ADDRESS: 1600-06 E BERKS ST

Proposal: Demolish building owing to necessity in the public interest

Review Requested: Final Approval

STRUCTURAL CONDITION APPRAISAL

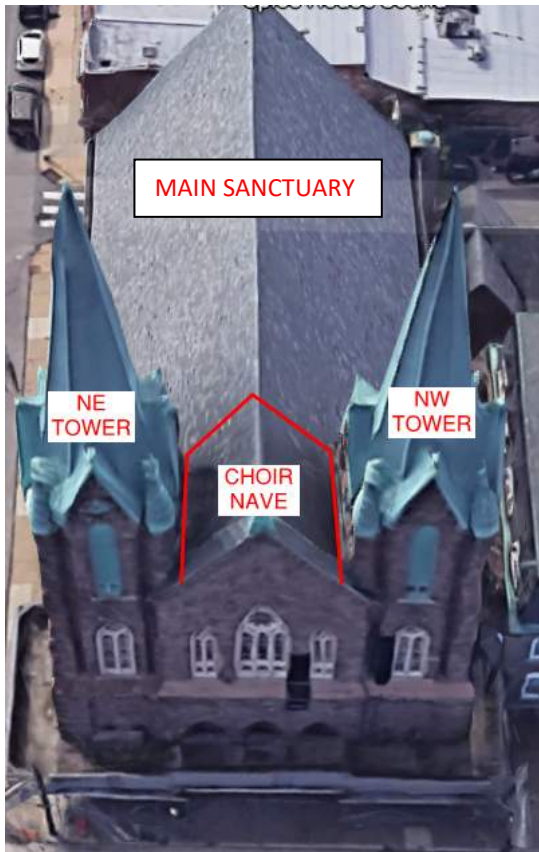
Below is an eastern elevation of the northeastern tower.
See labels for identification of different timber platform levels.

I performed a review of the existing conditions on June 29, 2020. My review consisted of visual observations of exposed conditions that were accessible without staging or uncovering. Locations noted below are identified on the elevations on page 4 of the Harman Group report. During my review, I observed the following:

- At the mid-level of west tower, significant cracking and out of plane displacement of opposing cracked surfaces at the head of the arch window openings.

- At the lower bell level of the west tower, significant cracking at the diagonal corner masonry. The remainder of the tower is inaccessible due to the bird carcasses and guano.

- At the mid-level of east tower, significant cracking at the head of the arch window openings.
- At the upper bell level of the east tower, large cracks and gaps are visible in the backup rubble stone at multiple locations and within the arched openings.

See below for an overall isometric of the building with a description of the structural system.

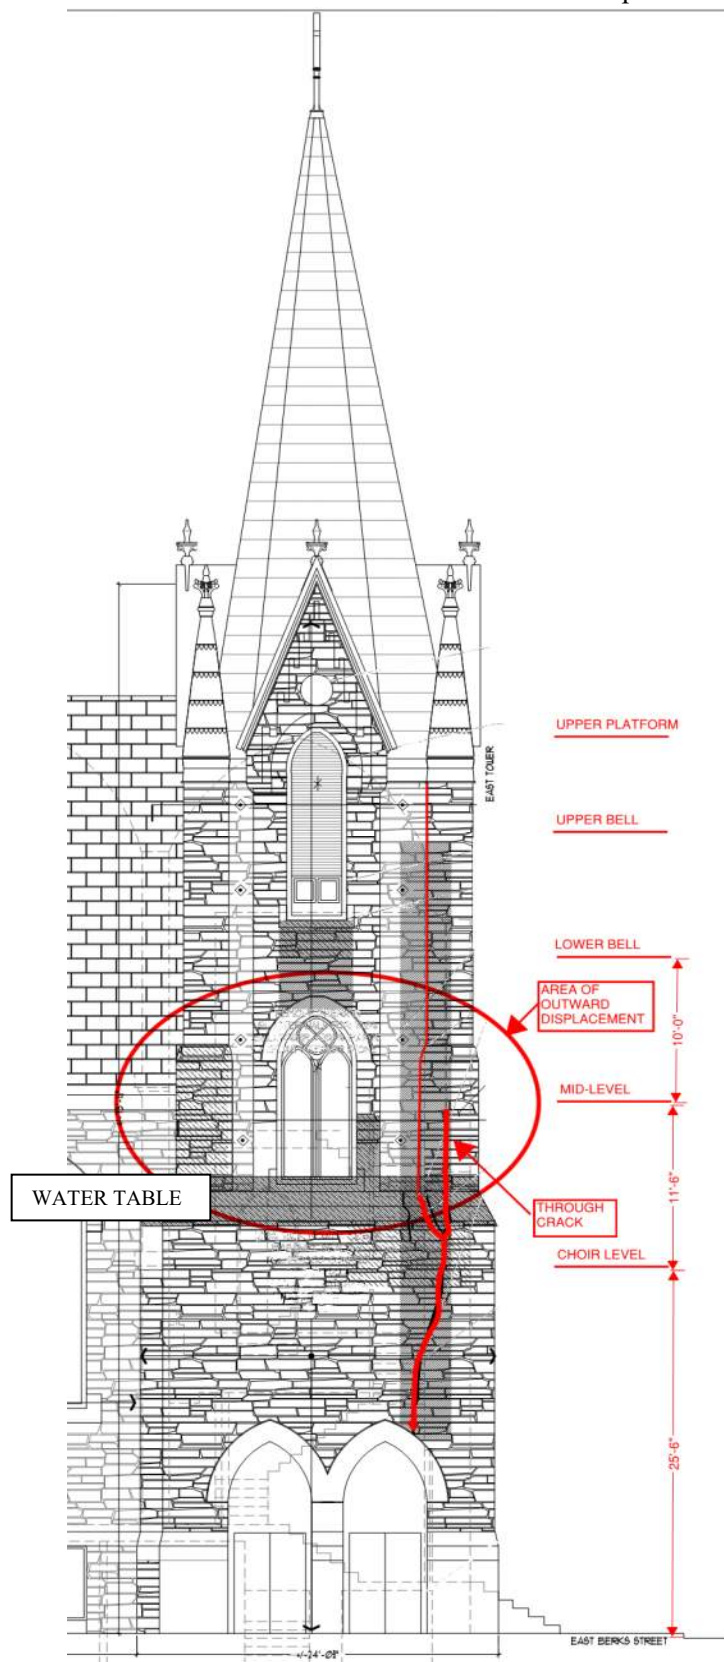
Main sanctuary: Timber trusses supported by cast iron columns and exterior load bearing masonry

Choir nave: Timber framing supported on load bearing masonry

Towers: Timber framing supported on load bearing masonry (see next)

Below is the framing plan for the main platform at the Lower Bell (see elevation page 4).

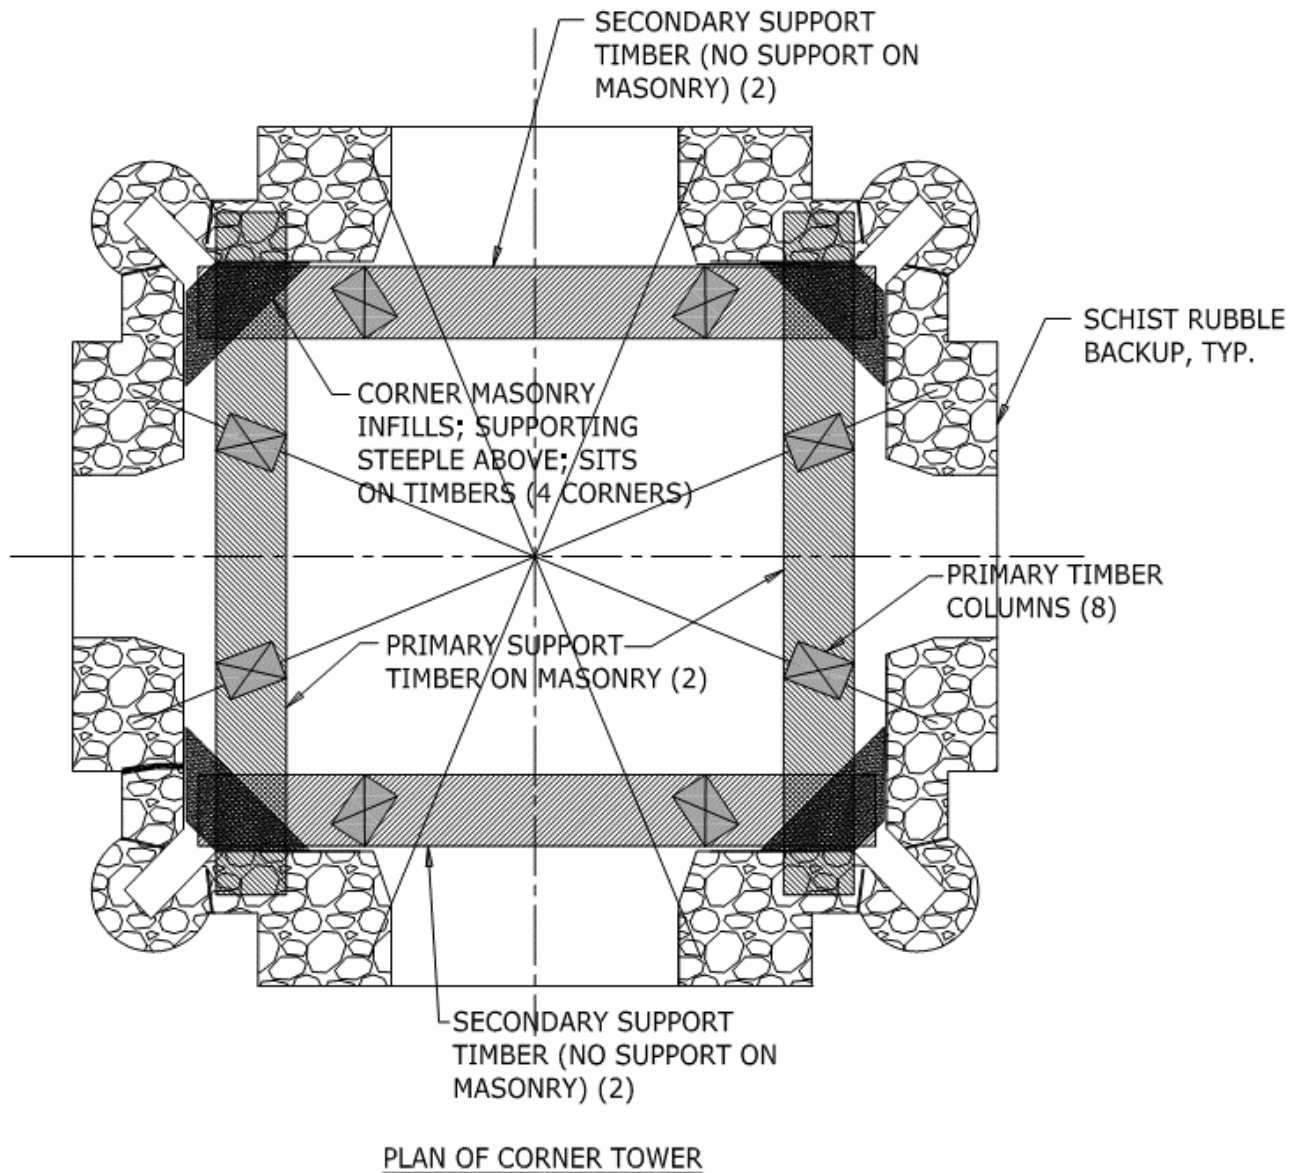
All timber above the Lower Bell that frames out the platforms (Upper Bell, Upper Platform and the steeple above) are supported by the girders at this Lower Bell Platform. There are no other ties between the timber and the masonry above. The main timbers that span to the northern and southern walls are supported by the masonry walls. The secondary timbers spanning east west are supported by the north south girders but do not tie into the masonry walls.

The method of framing the towers means that it the tower masonry above the water table (where the masonry projects out) is entirely dependent on the integrity of the corners for its stability.
